SITE PLAN DEVELOPMENT PLAN

WARREN AVENUE TOWNHOMES

1st Review
Ashley Duncan
Aurora Water Utilities
aduncan@auroragov.org

WARREN STREET TOWNHOMES SITE PLAN

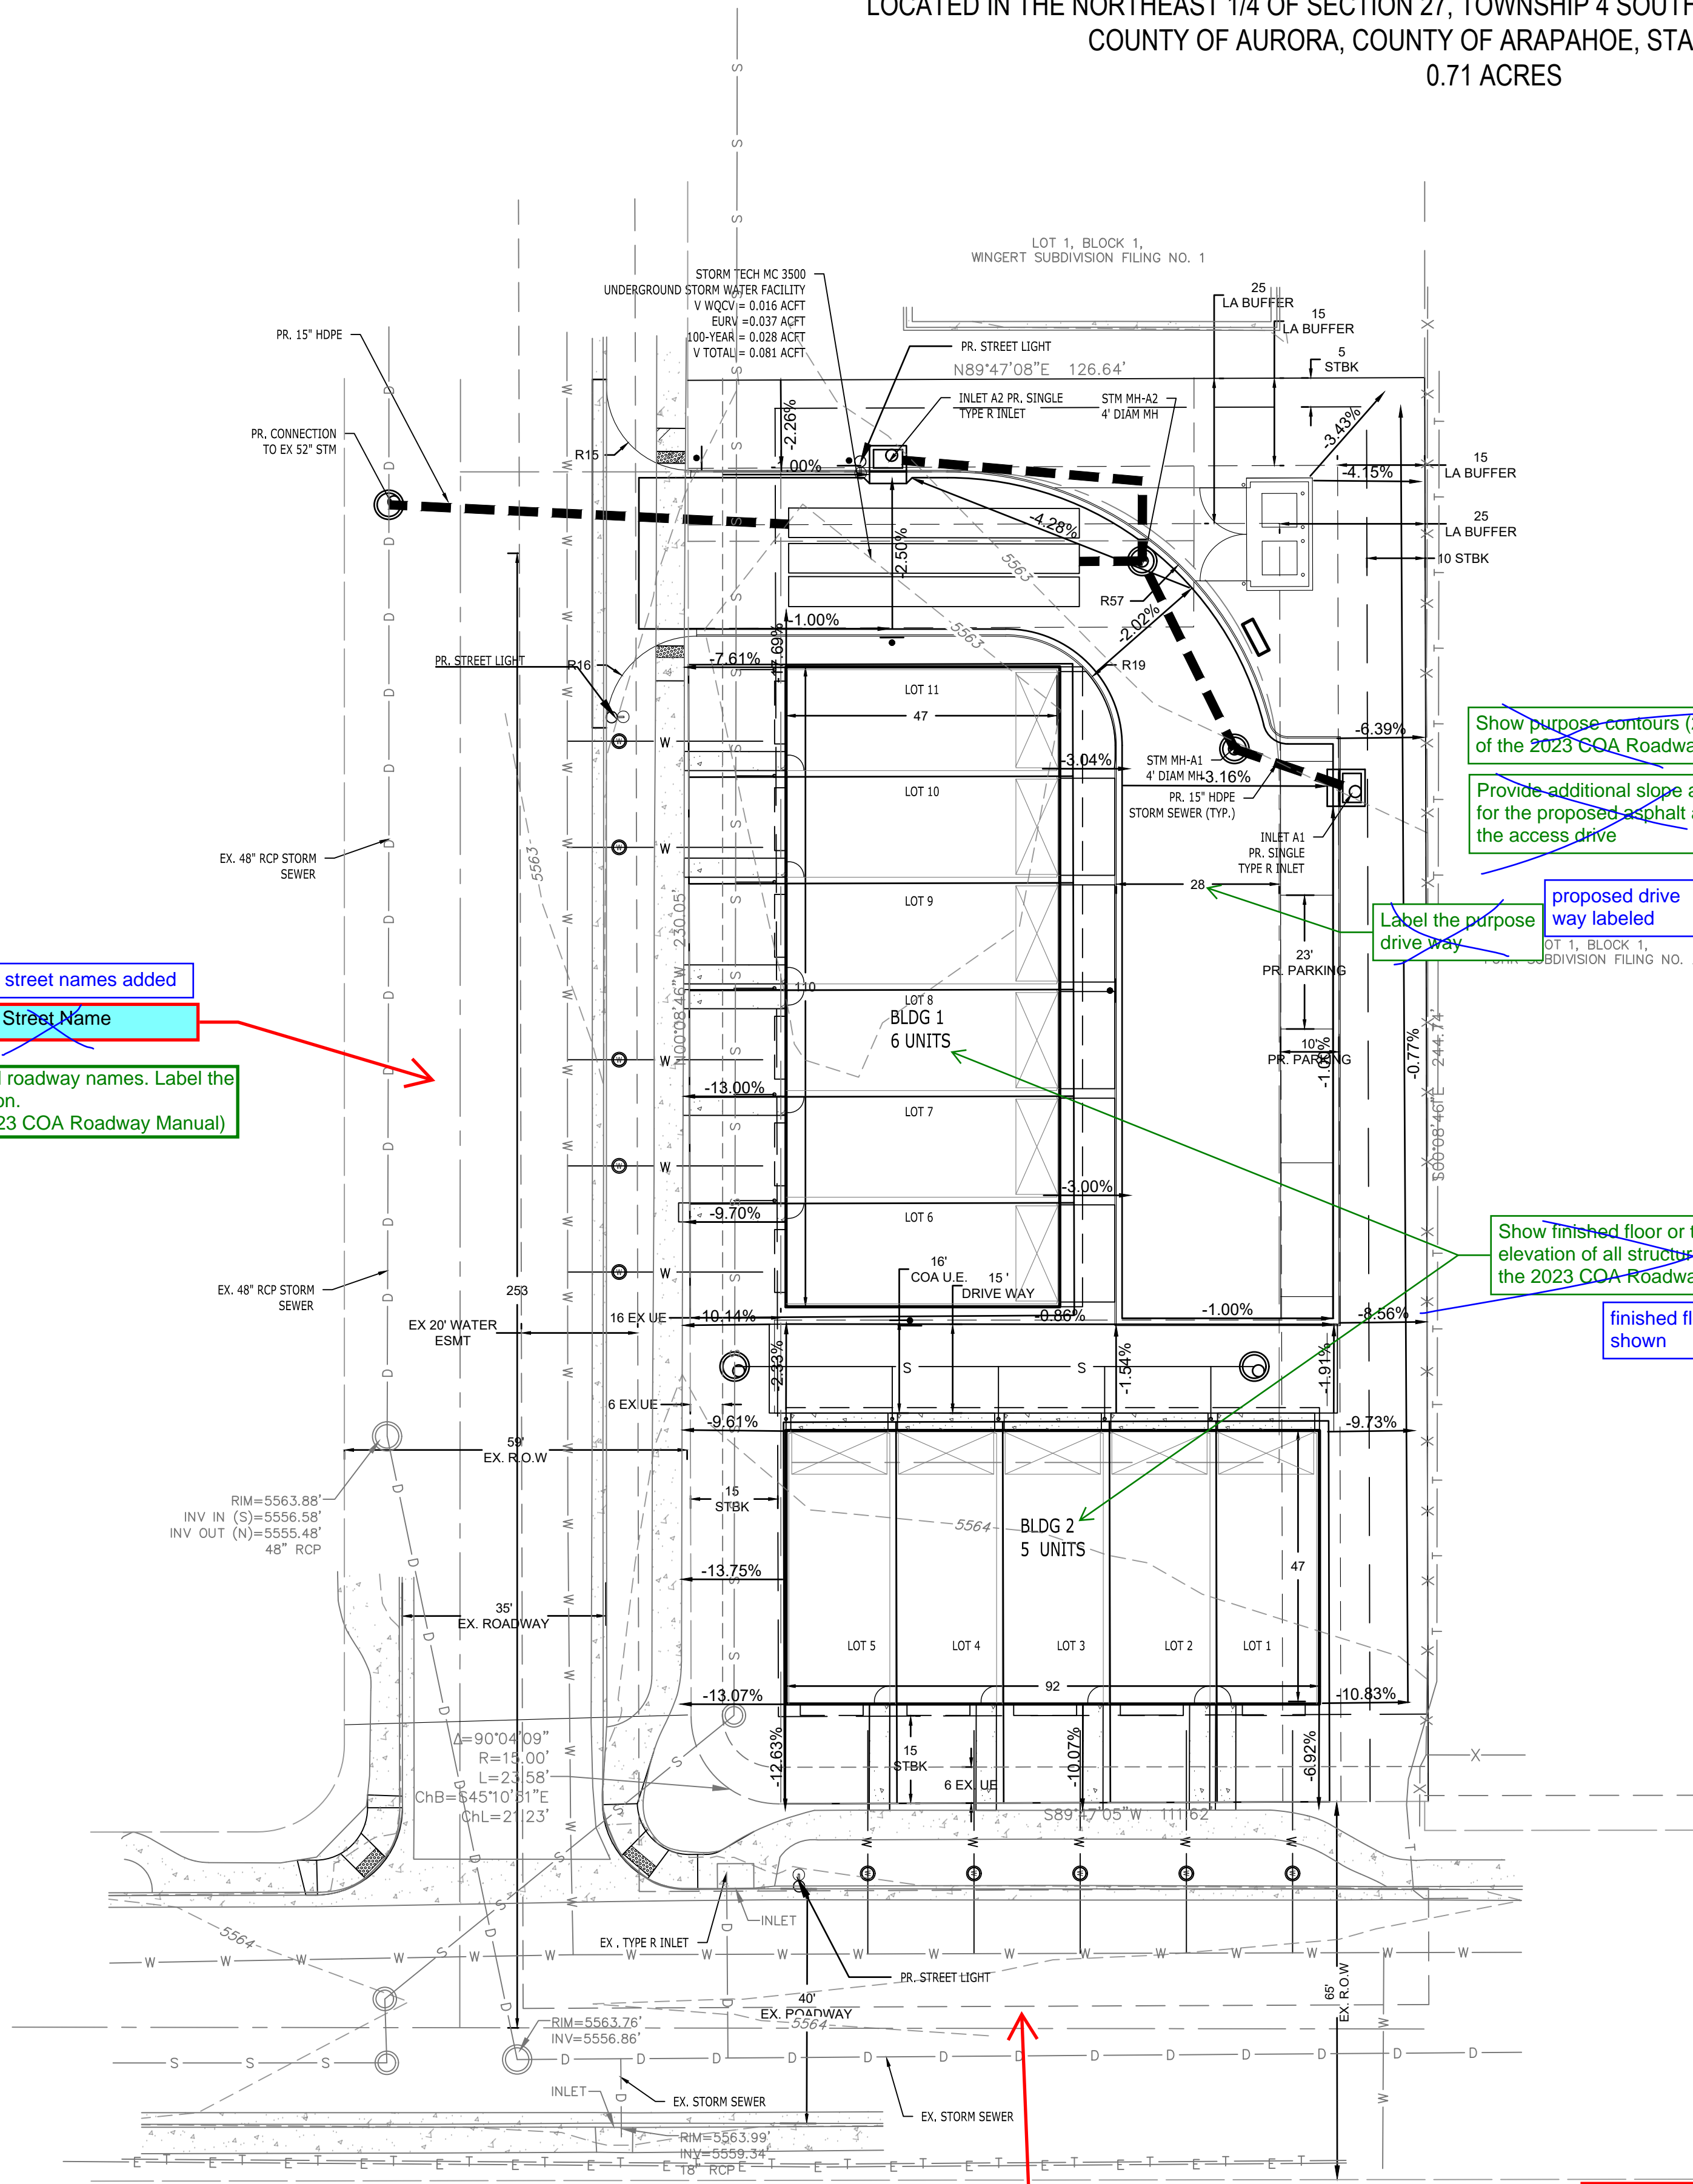
Show and label
accessible routes.

Show purpose contours (2.08.1.01
of the 2023 COA Roadway Manual)

Provide additional slope arrows
for the proposed asphalt and by
the access drive

Label the purpose
drive way

Show finished floor or top of foundation
elevation of all structures (TYP.) (2.08.1.03 of
the 2023 COA Roadway Manual)

Check the graphic scale. This
appears to be saying it's 40 scale
but it is actually 20 scale. Provide a
written scale as well.

see response to
accessible routes on
sheet 3

contours shown

additional slope
arrows added

proposed drive
way labeled

finished floor elevations
shown

scale revised

1 SITE LIGHTING PHOTOMETRIC

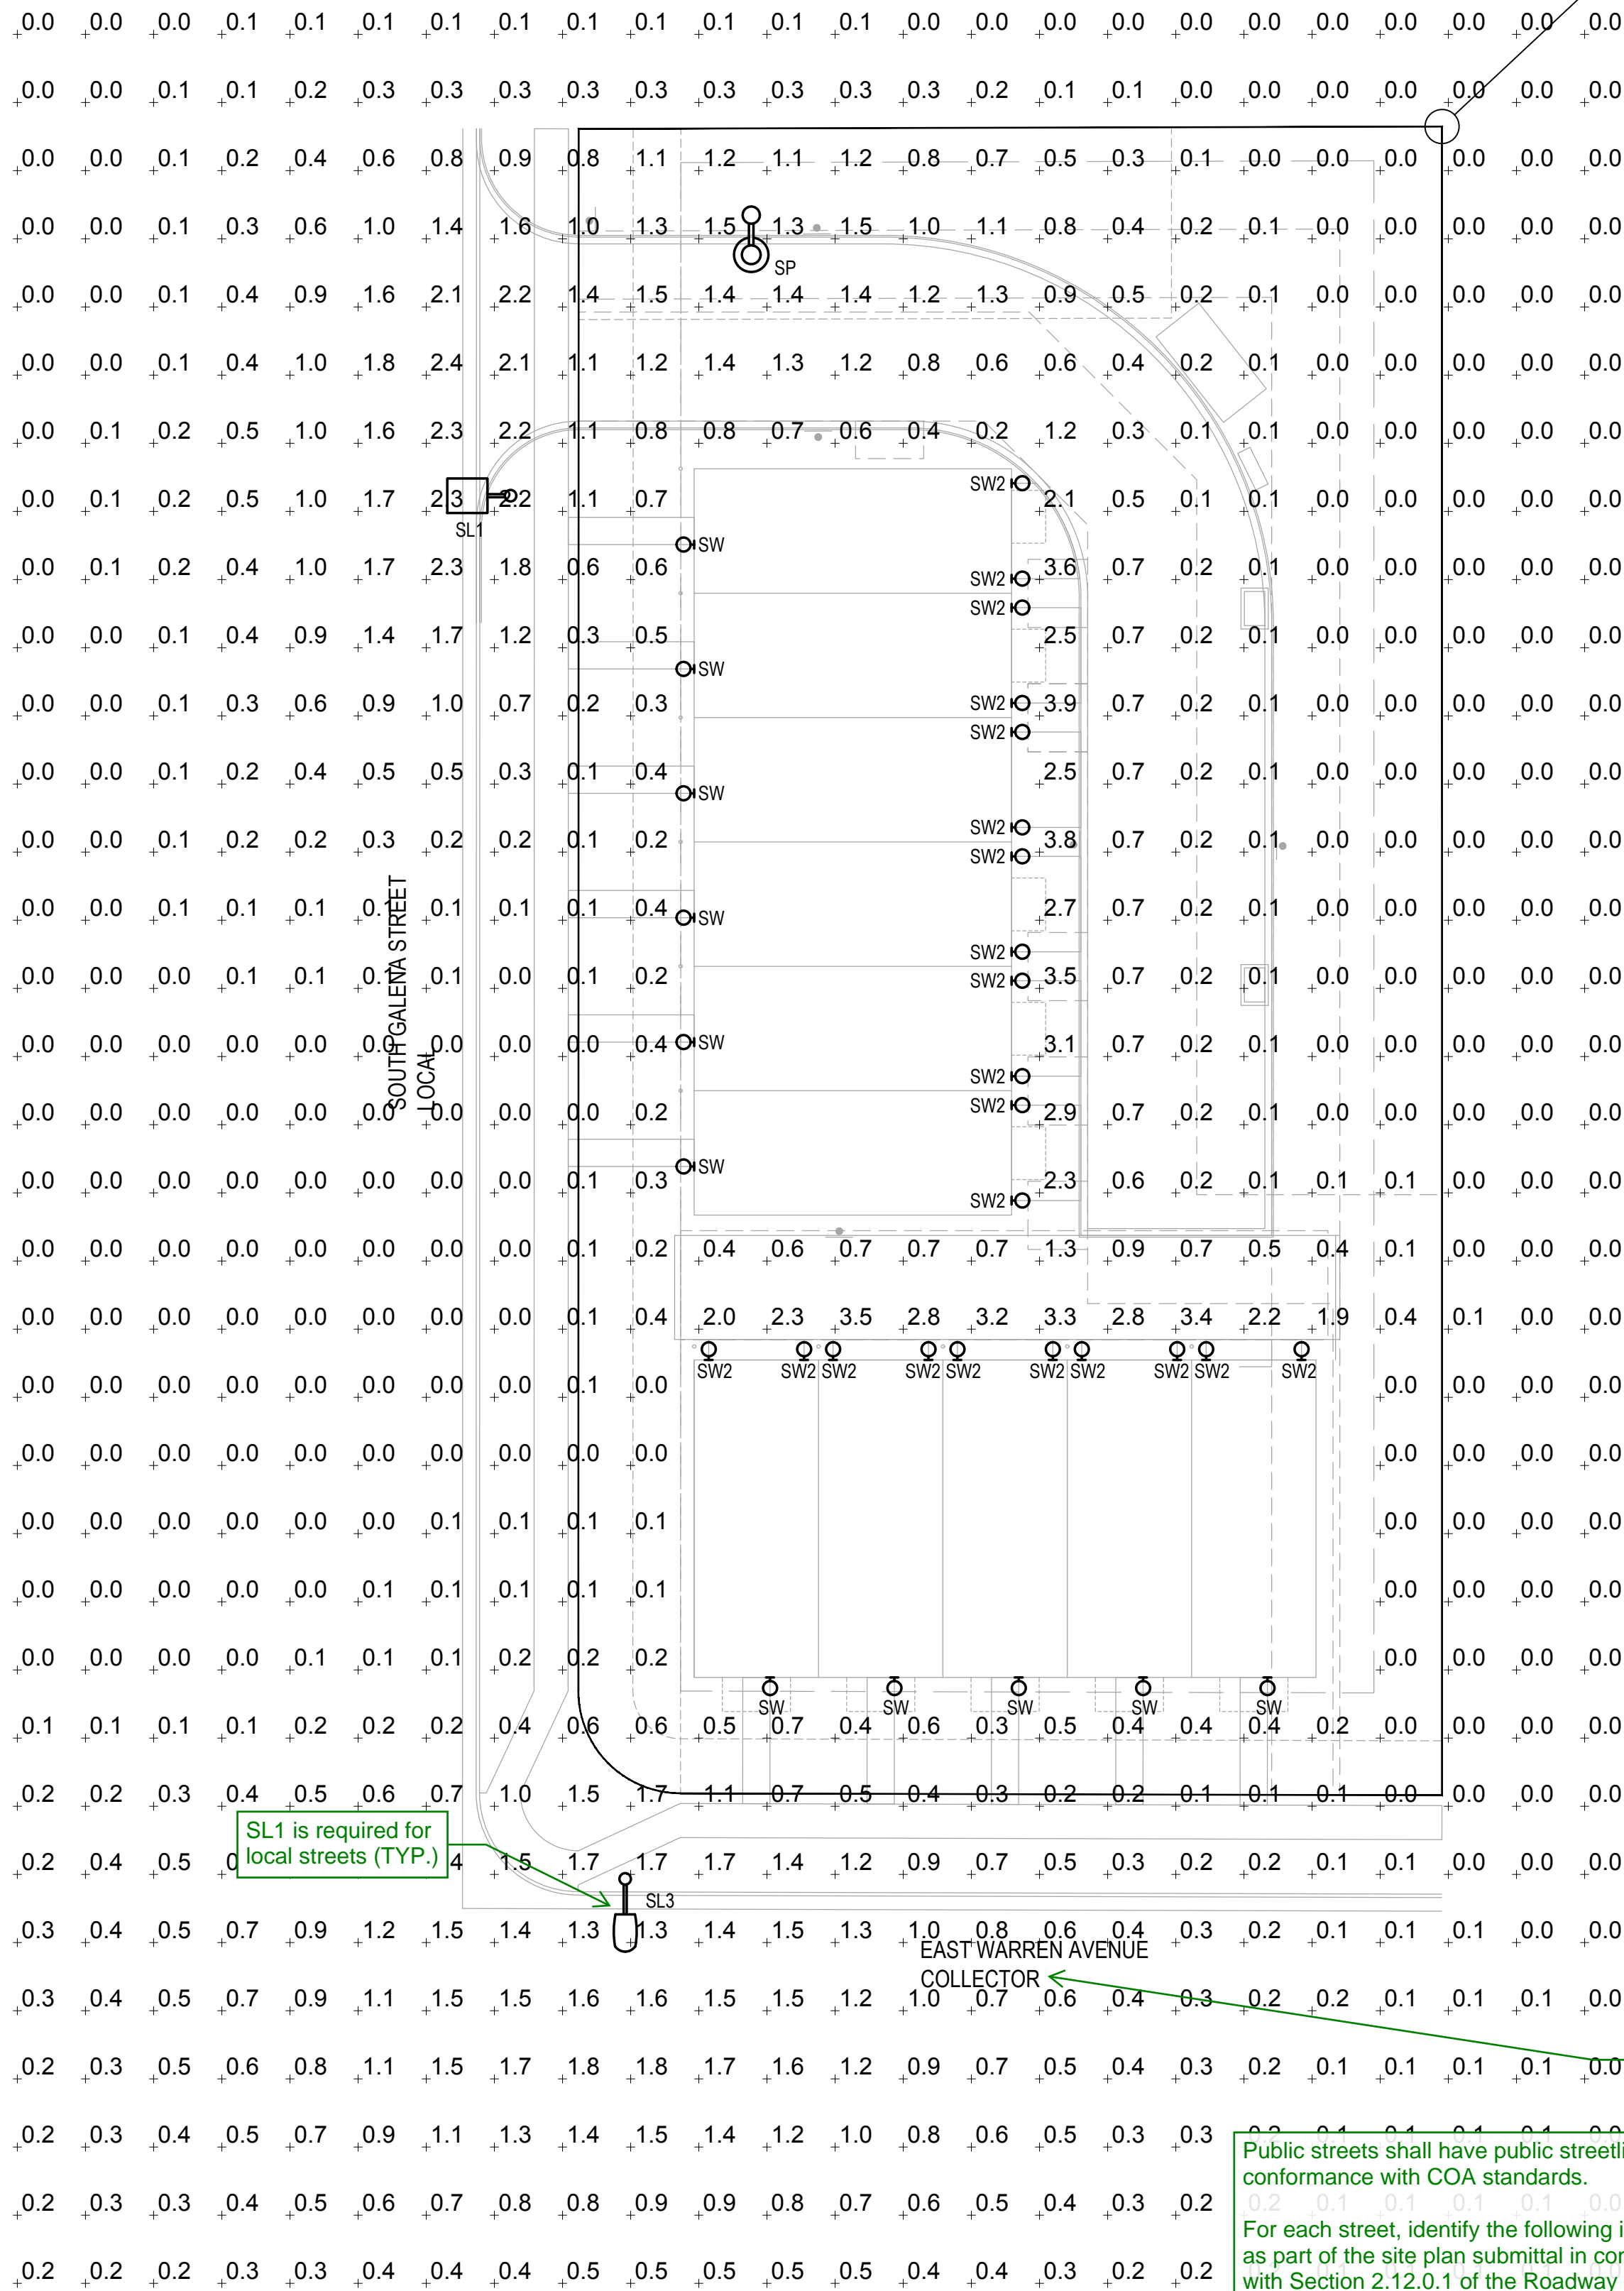
The path of travel for the exit discharge shall be illuminated to not less than 1 footcandle (11 lux) at the walking surface.

Show accessible routes on photometric plan. Make sure paths of egress meet criteria provided.

Please make sure the title is consistent with the other sheets (TYP.)

Please remove all public street light information as it is not needed in the site plan (off site lighting). These information will be needed at the civil plans
